PARTS & SERVICE NEWS

REF NO.	AA98024
DATE	March 4, 198

SUBJECT: Cylinder Head Gasket

PURPOSE: To introduce a new head gasket

Figure 1 (S)6D102
A: 0.50 mm Oversize
B: 0.25 mm Oversize

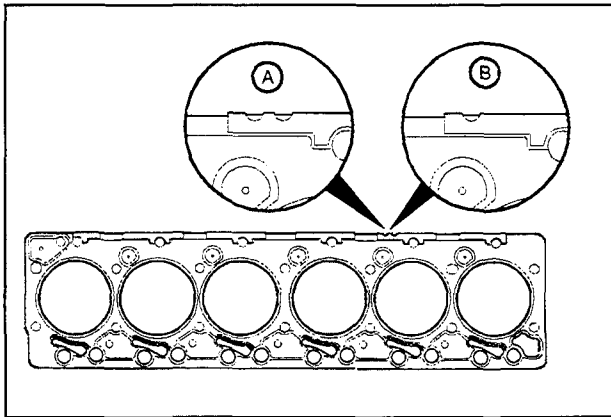
The oversized gaskets can be visually identified by notches in the outside edge of the gaskets (See Figure 1 and 2). One notch for 0.25 mm gaskets and two notches for 0.50 mm. The notches are located on the exhaust side of Cylinder No. 3 on (S)4D102 engine and Cylinder No. 5 on (S)6D102 engine.
